## 2.2 Carrington Road Walk and Cycle Improvements

### Consultation Summary Report

January 2017

Figure 1 Carrington Road proposals (1 of 4)

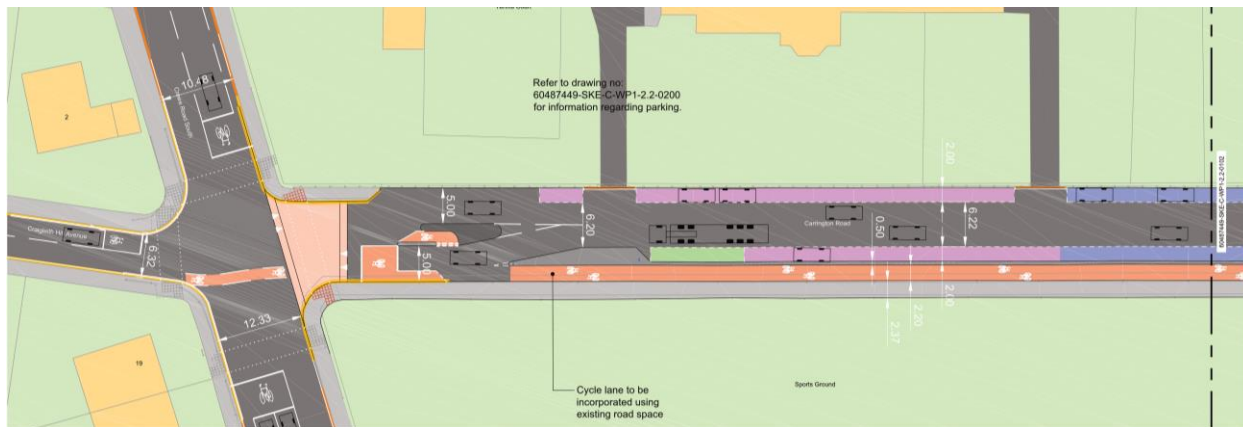
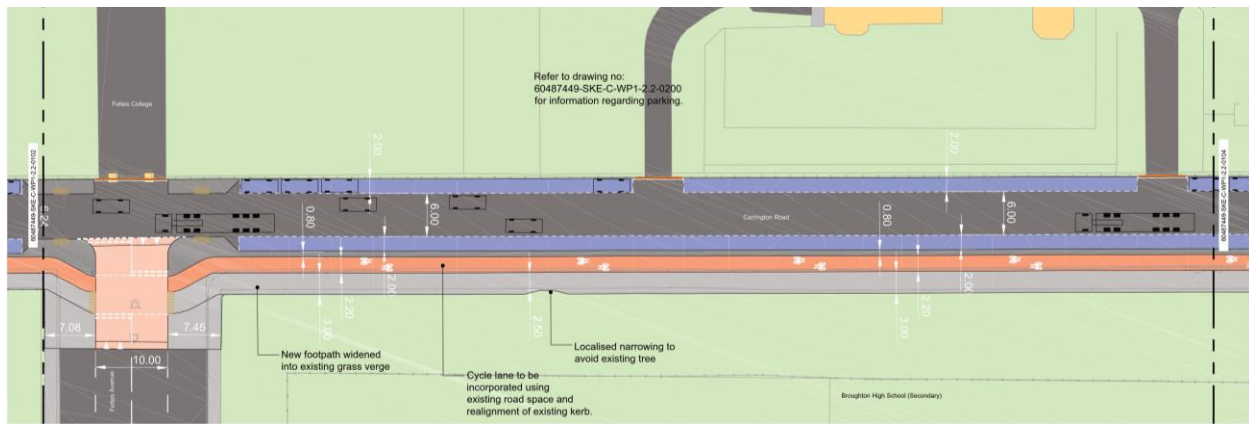
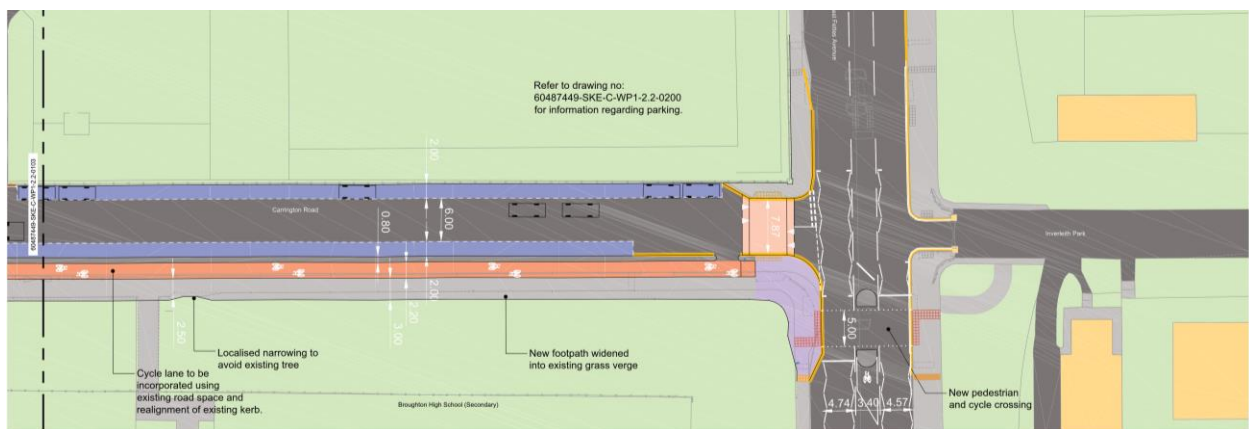
1.1. We don't understand why there are no markings across the junction for eastbound cyclists. Eastbound cyclists need to ensure they are in the middle of the road to access the proposed right turn into the cycle track and markings would help make this clear, both for cyclists new to the route and for drivers so they know where to leave room for cyclists. We believe this marking is even more important than the one shown in the plan for westbound cyclists (as they will be crossing the junction in a conventional way).

1.2. Several of our planning group members commented on the proposed junction design being generally awkward with the way that eastbound cyclists forced to try and cross traffic queuing on Carrington Road. It is also disappointing that segregation ends just at the point where cyclists need most protection -- at the junction. We recognise that this junction is a tricky section of route, but it is a critical section of the route and we wonder if there are other options you could consider...

1.3. Could the two way section continue all the way across the junction into a build out on Craigleith Hill Avenue? A sketch is attached (not to scale!). This would require moving back the stop line on Craigleith Hill Avenue, though probably not much further than the vehicle stop line at the beginning of the existing ASL (which would no longer be needed). We realise this would require changes to light timings to add a cycle phase, but the impact of this on other traffic could be minimized by skipping the cycle phase if no cyclists want to use the crossing (as detected by inductive or microwave detectors at the stop lines and on the cycle approaches). We would assert that changing the light timings is worth it if it results in a more usable junction for cyclists.

1.4. Another option might be to continue the two way section up to the junction but not across it (sketch also attached). This wouldn't be as cycle friendly but avoids the need for a fully separate cycle phase in the light timings. It would require separate phases for traffic coming from Craigleith Hill Avenue and from Carrington Road to ensure eastbound cyclists can safely access the two way track without vehicles emerging from Carrington Road at the same time. Westbound cyclists would proceed at the same time as the green from Craigleith Hill Avenue and drivers turning right from there into Crewe Road South would have to give way -- this may be a risk and markings would be important to make this clear, as would early cycle release so cyclists can enter the junction before vehicles from Craigleith Hill Avenue.

2.1. The existing traffic island here has a street light in the middle of it that is important for illuminating pedestrians using the crossing. It's not clear from the plans that this light is present in the proposed design but we feel it's important that replacement lighting of some form is provided to ensure the crossing is safe.

3.1 It's not clear how a cyclist travelling north would turn right from East Fettes Avenue into Inverleith Park -- the plan shows a cycle symbol in the middle of the road but there is a traffic island that would impede a right turn here and we presume no push buttons would be installed in the middle of the crossing so a cyclist could not actually use it. Please consider dropping the kerb at the south west side of the crossing (where the shared use pavement begins) so that a cyclist could use the crossing the in conventional way.

3.2 We also note the worn sections of grass around the L-shaped path linking into Inverleith Park -- these are evidence that this narrow path would benefit from being widened and rounded off at the point where it meets the main path through Inverleith Park.

1.1 We shall add an eastbound cycle lane across the junction of Crew Road South.

1.2 We shall also add adding a 'keep clear' area to Carrington Road between the right turn cycle lane and the segregated cycleway entrance. We shall also adjust the right turn lane area so that it is closer to the cycleway.

1.3/1.4 Due to the volume of traffic at the junction, a cycle only phase would be challenging to incorporate. However, we will consider an early cycle release, to help people cycling cross the junction ahead of traffic.

2.1 Current levels of street illumination shall be retained or improved.

2.2 Thank you for raising this. We shall remove the guardrail and parking outside this entrance. In place of the parking we shall install a build out of the pavement and install dropped kerbs for cycle, wheel chair access.

3.1 We shall add dropped kerbs on the west side kerb so people cycling can choose to use the crossing or to make the right turn without using the crossing when traffic is light.

3.2 The width and location of the path were agreed with the Friends of the Park and are constrained by mature trees, hedges and buildings. We are not proposing to alter it.
